Re: St. Lucie Units 1 and 2
Docket Nos. 50-335 and 50-389
Radiological Emergency Plan - Revision 63

**St. Lucie Plant
Radiological Emergency Plan – Revision 63
Summary of Changes
(2 pages)**

**St. Lucie Plant
Radiological Emergency Plan – Revision 63
Effective Date: December 19, 2014
(1 copy)**

**FIGURE 4-2
COMMUNICATIONS INTERFACES**

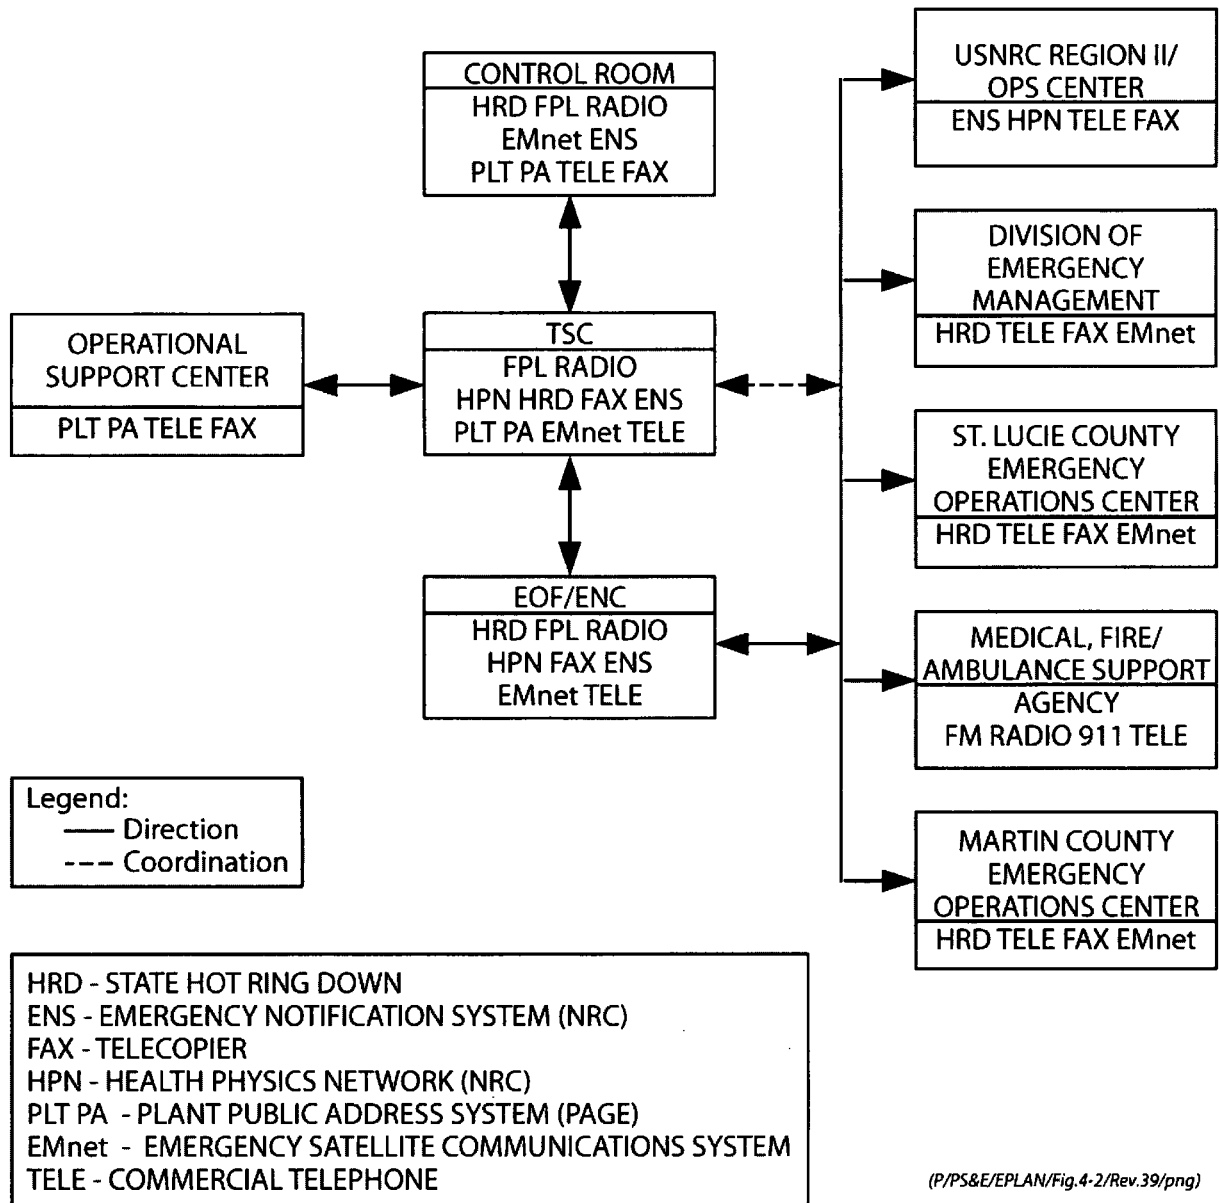
Sections 2.4.1, 4.1.1, 4.6 and Figure 4.2, remove the reference of "Bell" for telephone system.

FIGURE 5-1
PROTECTIVE ACTION RECOMMENDATIONS¹
 (Page 1 of 3)

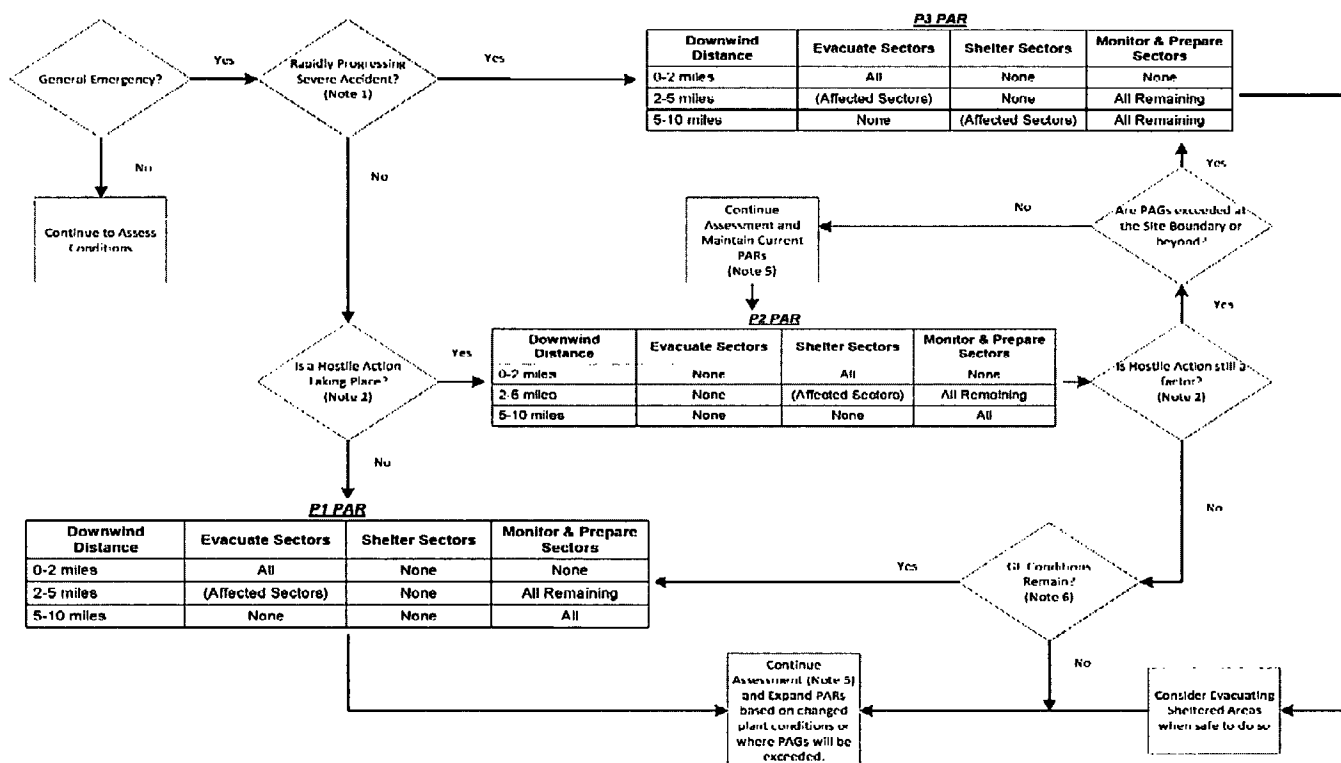
Revised Section 5, Response to Accident Conditions, to upgrade the Protective Action Recommendation process. The Protective Action Recommendation scheme is being revised due to changes in NUREG-0654, Supplement 3, using the endorsed guidance of NEI 12-10.
